Regular Town Council Meeting

December 4, 2023

1. LDR Text Amendment to Neighborhood High Density-1 Zone (P23-168) (Tyler Valentine) -
This item will be continued to 1/8.
2. Development Plan for Mixed Use Building at 655 and 665 S. Cache Street (P23-105)
(Katelyn Page)

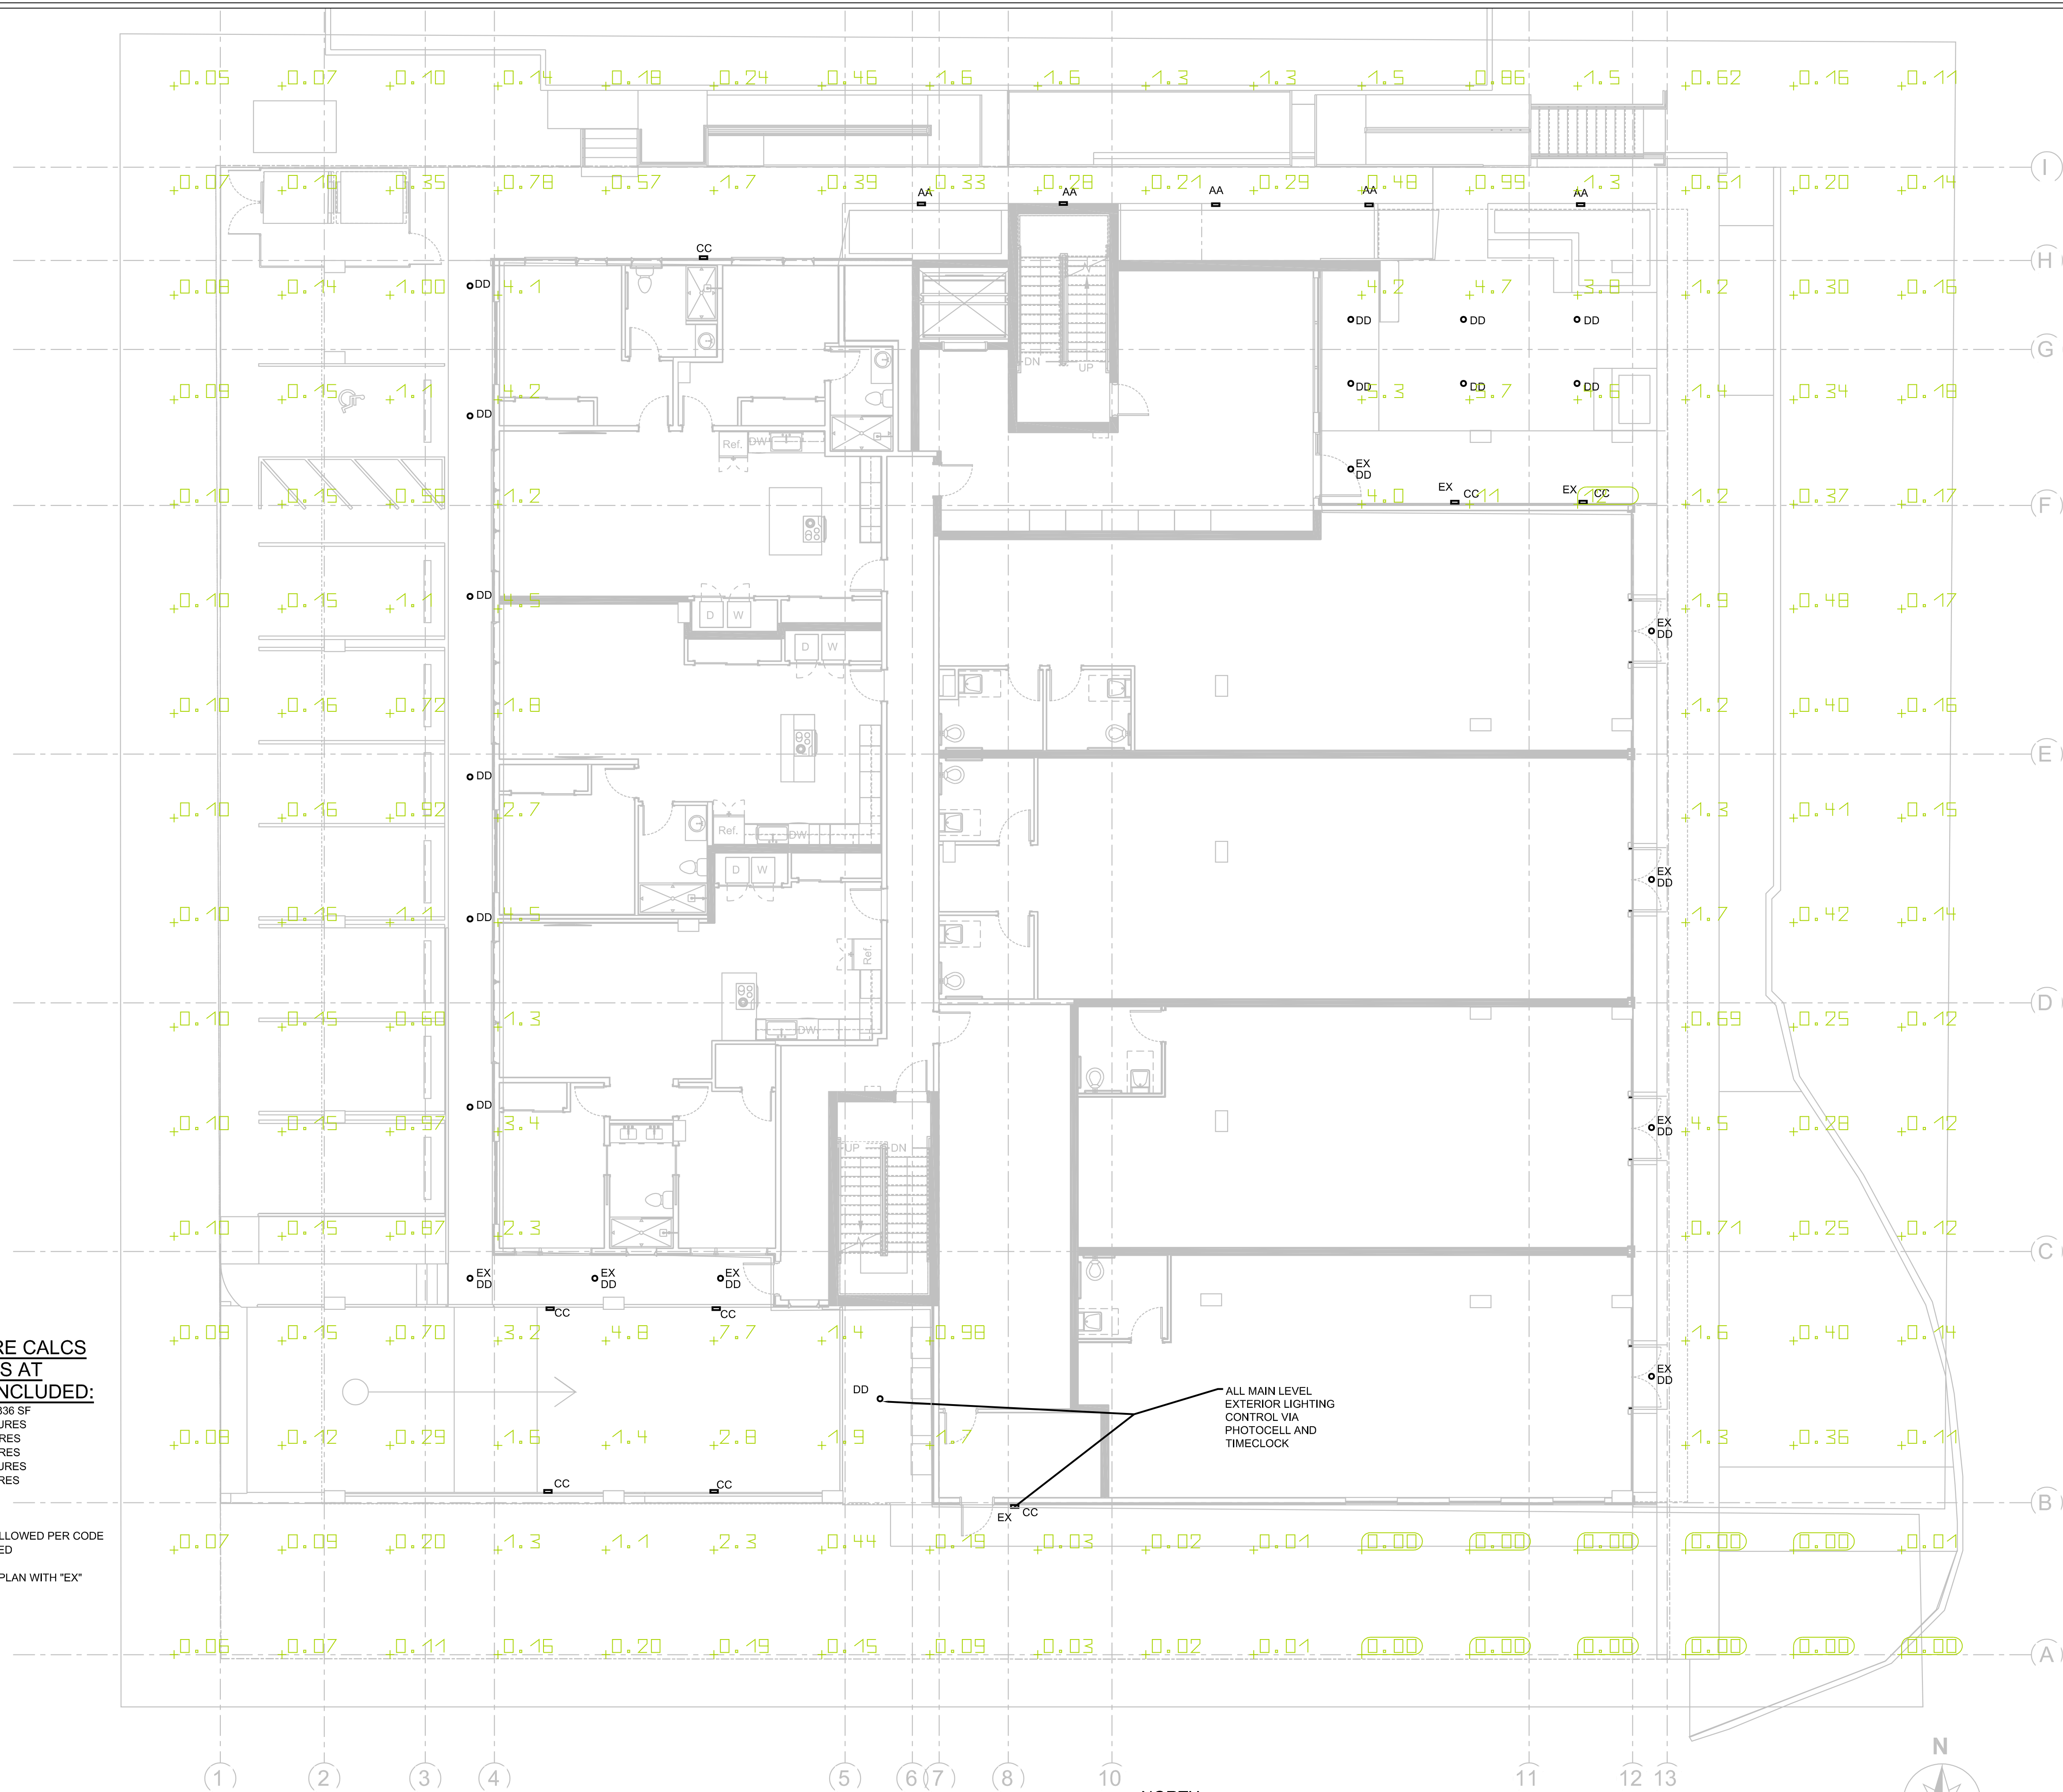
EX1.0 Revise lighting plan to show compliance with lumen maximum. LDRs were updated in 2022 for lighting standards. Based on site acreage of 0.46, the CR-1 zone is allowed a maximum of 3 lumens per sf of site development but is limited by a maximum of 50,000 lumens per acre of site development for all fixtures and a maximum of 2000 lumens per acre of site development for unshielded fixtures. All lights over 600 lumens shall be fully shielded and light color may not exceed 3000 kelvin. Staff requires the site development area in order to confirm maximum lumens, however, it is likely it will be closer to half the amount currently proposed.

EX1.0 –Revise lighting plan to show compliance with lumen maximum. LDRs were updated in 2022 for lighting standards. Based on site acreage of 0.46, the CR-1 zone is allowed a maximum of 3 lumens per sf of site development but is limited by a maximum of 50,000 lumens per acre of site development for all fixtures and a maximum of 2000 lumens per acre of site development for unshielded fixtures. All lights over 600 lumens shall be fully shielded and light color may not exceed 3000 kelvin. Staff requires the site development area in order to confirm maximum lumens, however, it is likely it will be closer to half the amount currently proposed. Revise plans to include total amount of site development so staff may verify above lumen maximums.
